APPLICATION NO.	FILING DATE	FIRST NAMED INVENTOR	ATTORNEY DOCKET NO.	CONFIRMATION NO.
10/005,000	12/07/2001	James H. Lee	H-204145	1829

Application Number: 10/005,000
Filing Date: December 07, 2001
Appellant(s): LEE ET AL.

EXAMINER'S ANSWER

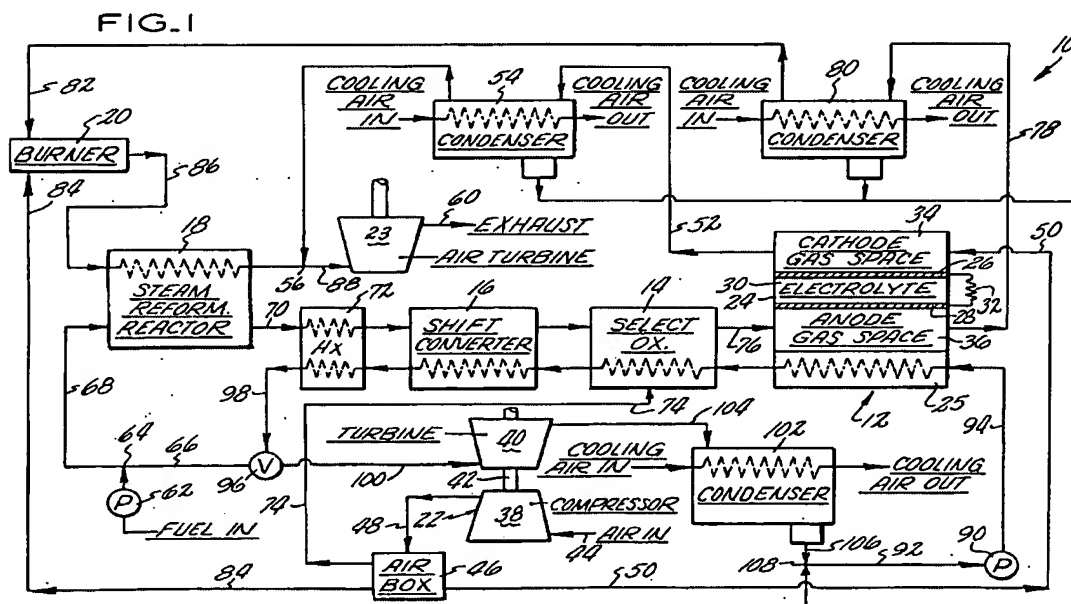
Bloomfield discloses a fuel cell power plant (TITLE) and the process of operating it (COL 5, lines 59-60) comprising as shown in **Figure 1** below a pump 90 delivering water via a conduit 92 into thermal exchange relationship with stack 12 via a conduit 94 by passing the water through the thermal exchange portion 25 of the stack (COL 5, lines 28-32). It is disclosed the fuel cells comprises a single cell 24 and a thermal management portion 25 (COL 3, lines 23-27). Bloomfield discloses that the liquid is increased in pressure by pumps (COL 4, lines 1-5). Bloomfield further discloses that part of the water is changed to steam as it passes through the stack 12. The water and steam is superheated by passing it into heat exchange relationship with the fuel conditioning apparatus. It is further heated in the selective oxidizer 14 and the shift converter 16 and in the heat exchanger 72 (COL 5, lines 32-40). The steam then leaves the heat exchanger 72 and is delivered to a valve 96. Then, the remainder of the superheated stream is delivered into turbine 40 (*the expander*) via a conduit 100. The turbine drives the compressor 38

Bloomfield further teaches that the exhaust from the turbine 40 is delivered into a condenser 102 via a conduit 104. Heat is removed from the steam by passing air through the condenser as shown. Liquid water, or possibly a mixture of liquid water and steams, leaves the condenser 102 via a conduit 106 and is combined at 108 with water recovered from the anode and cathode effluent gas streams in the condensers 54, 80. The water is then delivered to the pump 90 via the conduit 92 and the process starts again (COL 5, lines 50-62). It is disclosed that the amount of water lost in the Rankine cycle loop is recovered in the condensers 54, 80 and which is combined at 108 with the water which recirculates through the loop (COL 6, lines 1-6).

In summary, Bloomfield's **Figure 1** below illustrates the specific pump 90, the heat generating fuel cell system 24, the turbine 40 (the expander), the compressor 38 and the condenser 102 satisfying the specific spatial relationship, functional configuration and procedural steps as instantly claimed (*← emphasis added*).
